2024-25 Design, Build, Fly Q&A #1

General Questions

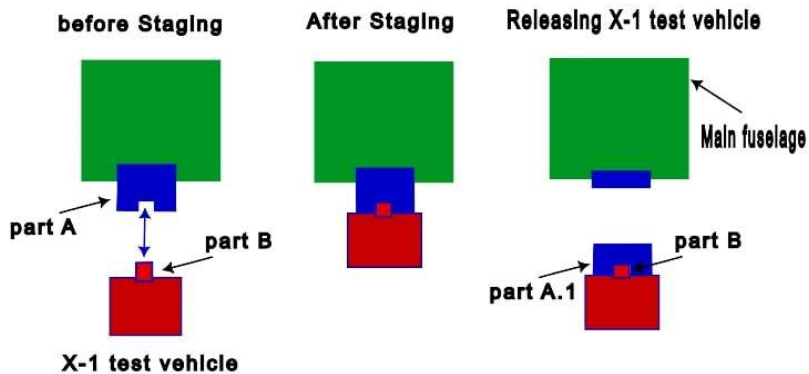
47. Can the X-1 glider be carried between the twin-booms?

For our design, can the X-1 glider be carried between twin-booms?

Answer: Yes. But if the X-1 test vehicle attachment and release mechanism are NOT internal to the fuselage, it cannot be installed for M1 or at the start of the GM, where installation is part of the timed event. The mechanism must be attached to the airplane before attaching the X-1 test vehicle to the mechanism. It may be installed for M2 and M3 prior to entering the staging box.
